RS-16-236

Nine Mile Point Nuclear Station, Units 1 and 2
Renewed Facility Operating License Nos. DPR-63 and DPR-69
NRC Docket Nos. 50-220 and 50-410

Subject: Fifth Six-Month Status Report For Phases 1 and 2 Overall Integrated Plan in Response to June 6, 2013 Commission Order Modifying Licenses with Regard to Reliable Hardened Containment Vents Capable of Operation Under Severe Accident Conditions (Order Number EA-13-109)

**Fifth Six-Month Status Report for Phases 1 and 2 Implementation of Order EA-13-109,
Order Modifying Licenses with Regard to Reliable Hardened Containment Vents Capable
of Operation Under Severe Accident Conditions**

Sketch 1A: Electrical Layout of System – HCVS

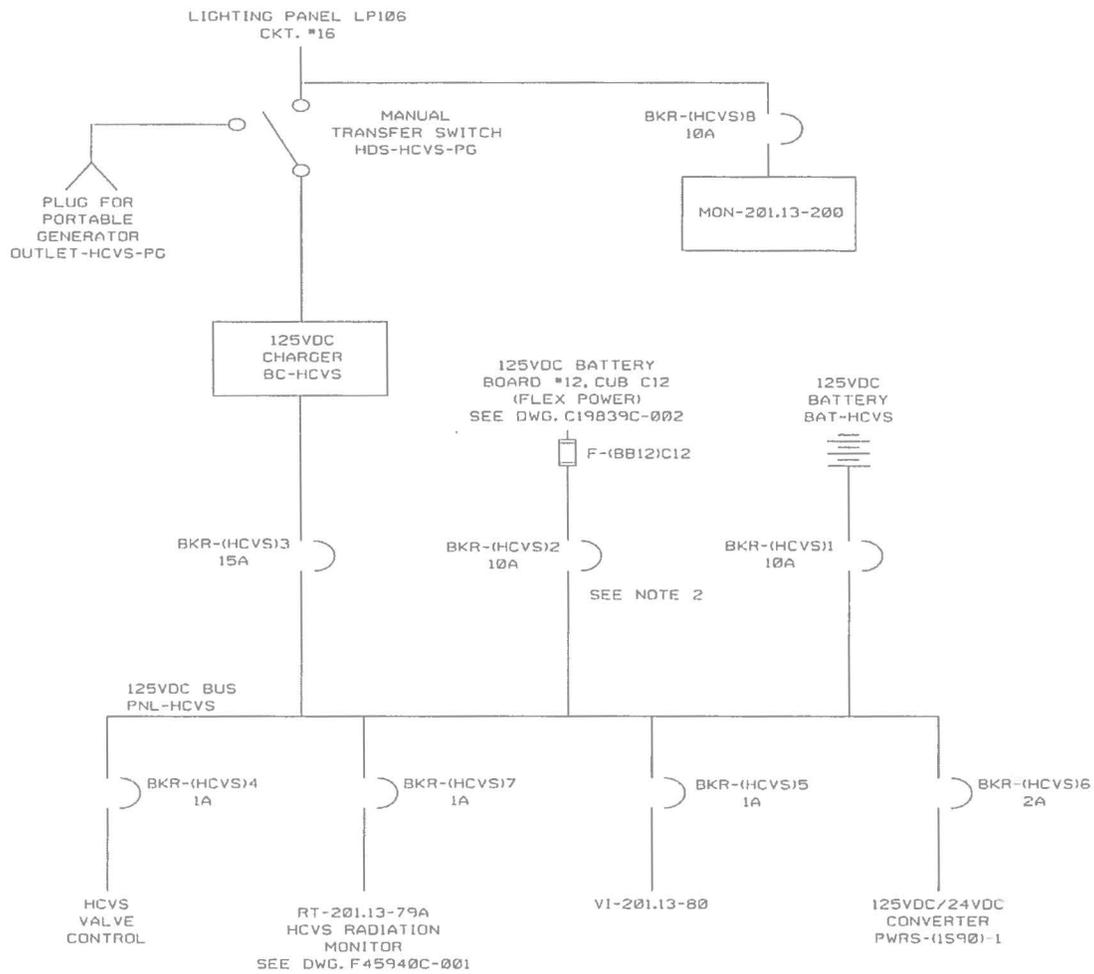
OIP Sketch 1A: This sketch is out-of-date. The attached ECP-13-000086-MU-039 F45940C-002 provides an updated electrical layout of the HCVS.

Secondly, in the Reference 10 HCVS Phase 2 ISE, sections 3.1.2 and 3.3.2.1, the NRC staff makes reference to HCVS power supplies based on information provided in the Reference 7 combined Phases 1 and 2 OIP. Changes to the HCVS power supply design described in the OIP have been made in the final design that necessitates a revision to the OIP discussion. Below is a revision to each OIP section impacted which shows the changes made to the HCVS power supply summaries.

Establishing temporary power to repower the battery charger. Option 1 is to connect the FLEX DG to Station Battery Charger #12, which provides power to Station Battery Bus #12 that in turn powers the HCVS components. Option 1 would be completed as part of the FLEX response strategy and occurs to the south and inside the NMP Turbine Building. Option 2, to be taken if the FLEX DG cannot be connected to the Station Battery Charger #12, is to connect a small portable generator to the HCVS battery charger. Option 2 would be taken locally at the HCVS ROS Area. Either of these actions will also require the generators to be refueled. A one line diagram of the electrical system to be installed is included in sketch 1A.
